**Subject:** Data Gaps Work Plan

**Subject:** Conditional Approval of Surface Geophysical Data Collection portion of Data Gaps Work Plan

Figures to Accompany  
*Conditional Approval of Surface Geophysical  
Data Collection portion of Data Gaps Work Plan*

**To:** EPA  
**Copy To:** File 80021  
**From:** J. Lambert, J. Brunelle  
**Subject:** Olin: Comprehensive Data Gaps Work Plan Review Comments  
**Date:** 8/22/19

Figure 7

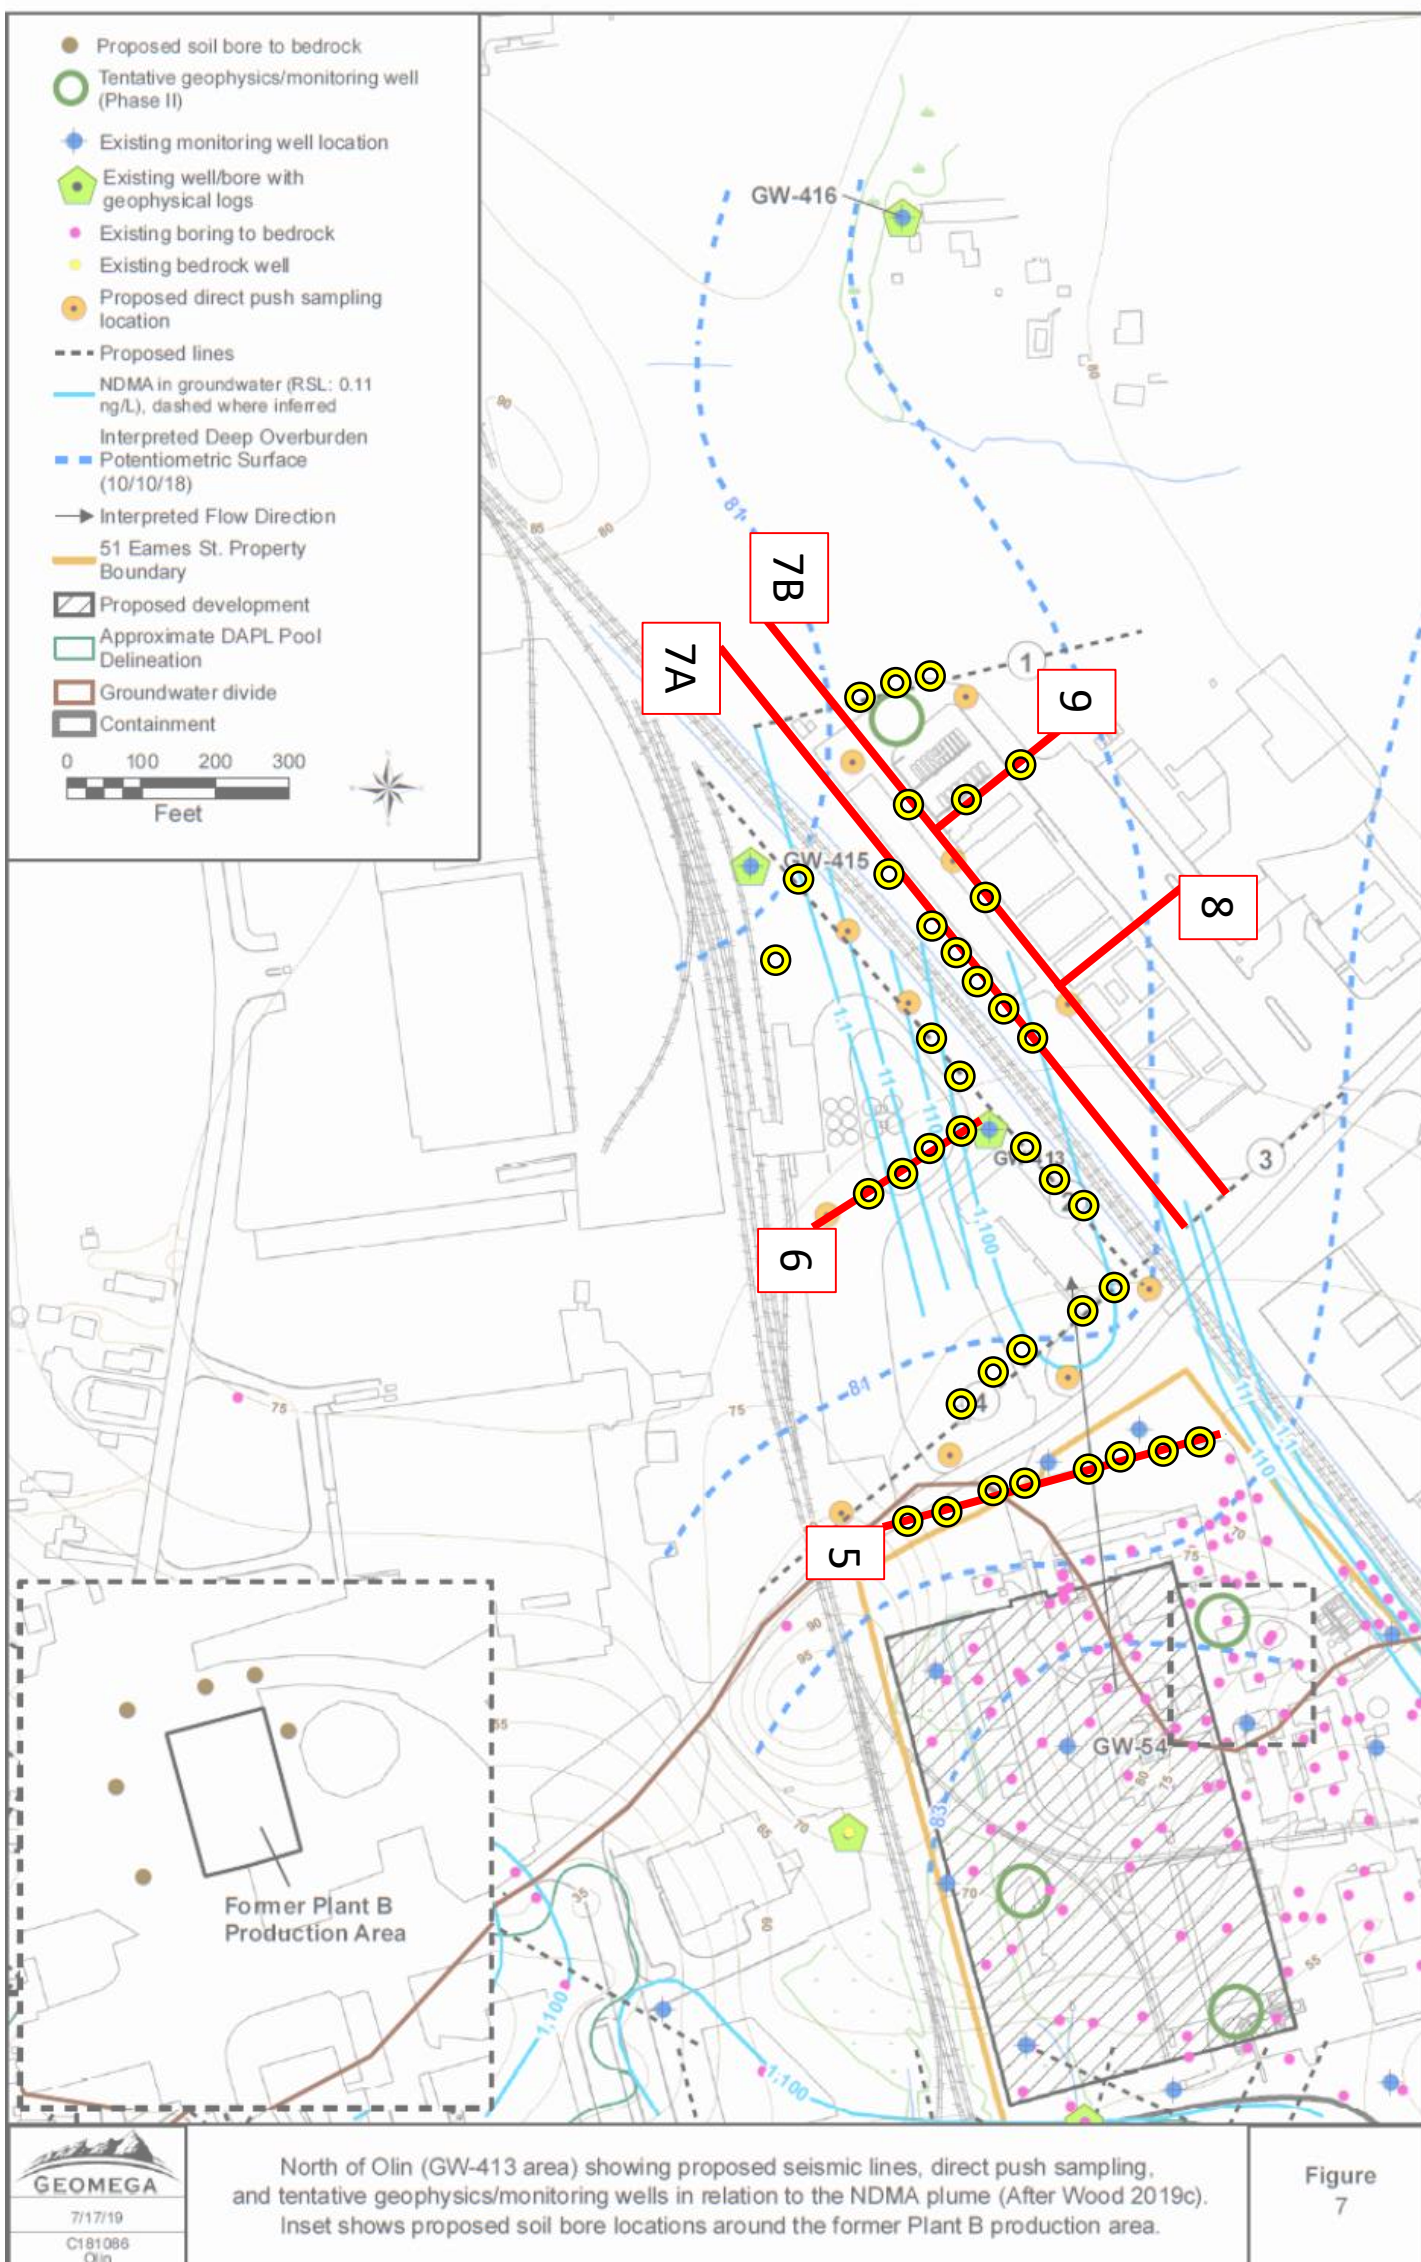
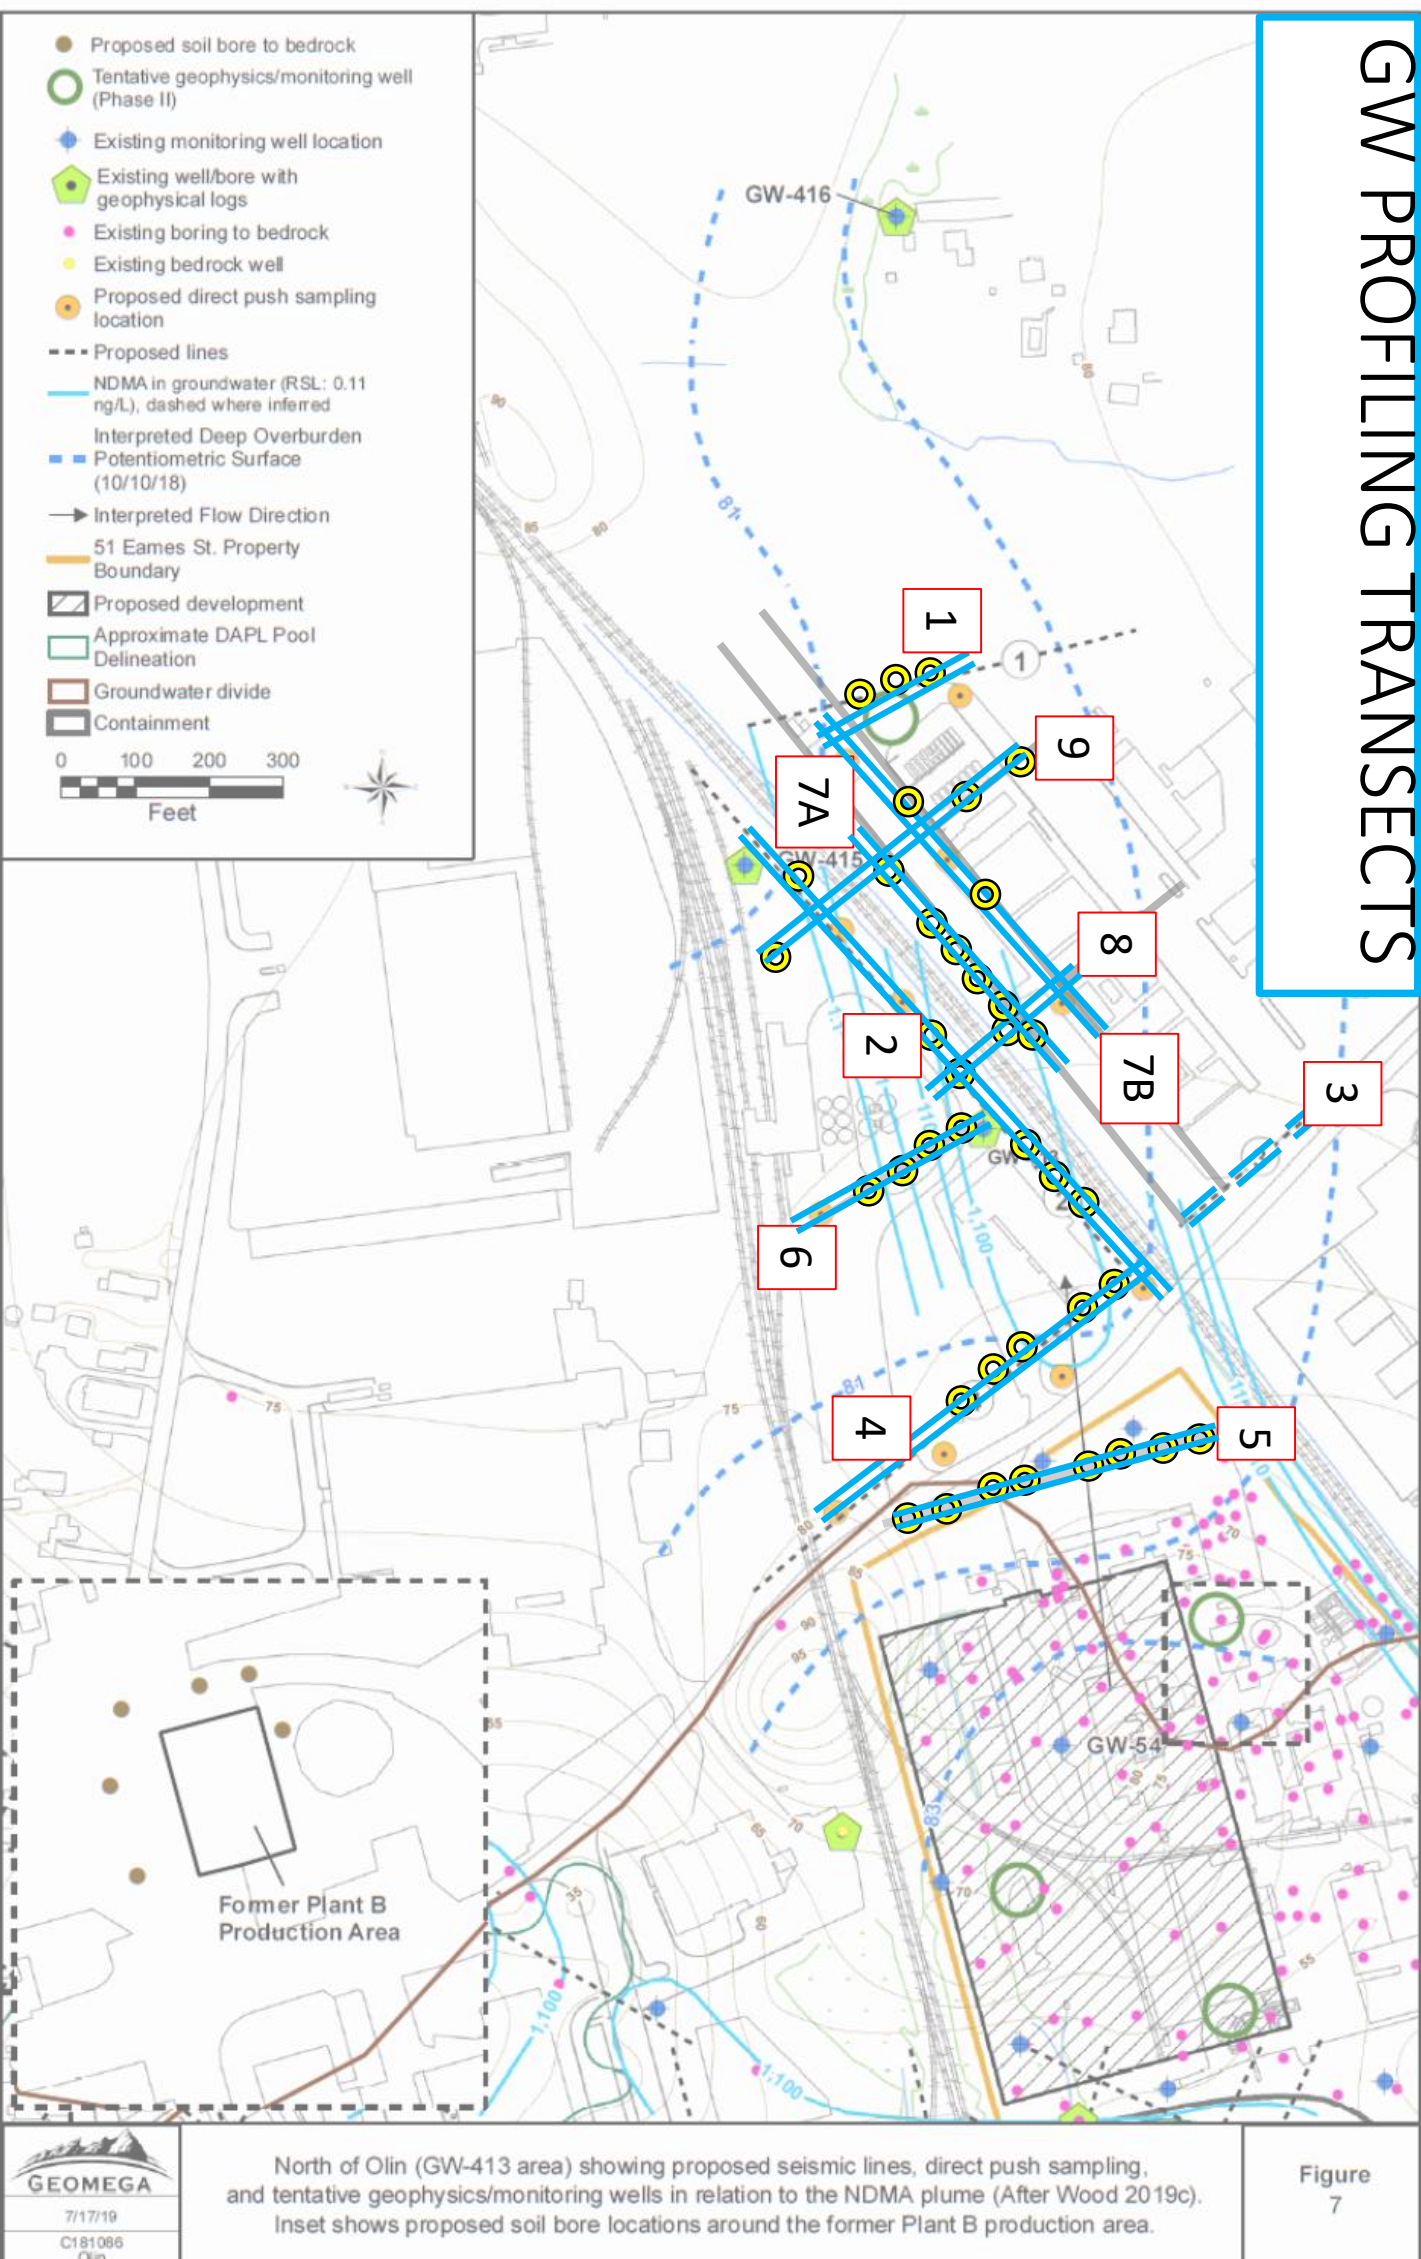
Geophysical Survey Line	Status	GW Profiling Transects/Comment
1	Concur/Modify	GW profiling transect should be adjusted to follow seismic line 1. At least 2 new GeoProbe locations needed to resolve plume core; (see Figure).
2	Concur/Modify	GW profiling transect follows seismic line 2 alignment; at least 5 additional GeoProbe locations needed to NNW and SSE of GW-413 along seismic line 2 to resolve plume core (see Figure).
3	Concur	No confirmatory GeoProbe locations are planned, but this should be reevaluated following completion of seismic data

4	Concur	At least 3 additional GeoProbe points needed along transect which generally follows seismic line 4 transects; new points focused to delineate core location (see figure)
5	New	New 500-ft Seismic reflection line proposed south of Eames street; New GeoProbe transect of 8 locations with a lateral spacing of ~ 50 ft. (see figure).
6	New	New 300-ft Seismic reflection line proposed SW of GW-413 to define western edge of plume core; see Figure for proposed Geoprobe locations.
7A	New	New 1000-ft NW-SE oriented seismic reflection line proposed NW of RR tracks; GW profiling transect follows seismic alignment; at least 4 new GeoProbe points needed; see Figure.
7B	New	(Alternate to 7A); New 1000-ft NW-SE oriented seismic reflection line proposed NE of RR tracks in roadway between warehouses; GW profiling transect follows seismic alignment; at least 2 new GeoProbe points needed to augment existing transect in plume core region; see Figure.

8	New	New 200+-ft SW-NE oriented seismic reflection line proposed to define eastern plume core boundary; at least 1 new GeoProbe point needed to augment existing transect in plume core region; see Figure.
9	New	New 200+-ft SW-NE oriented seismic reflection line proposed to define eastern plume core boundary in region ~ 300 ft north of transect 8; at least 1 new GeoProbe point needed to augment existing transect in plume core region; see Figure.
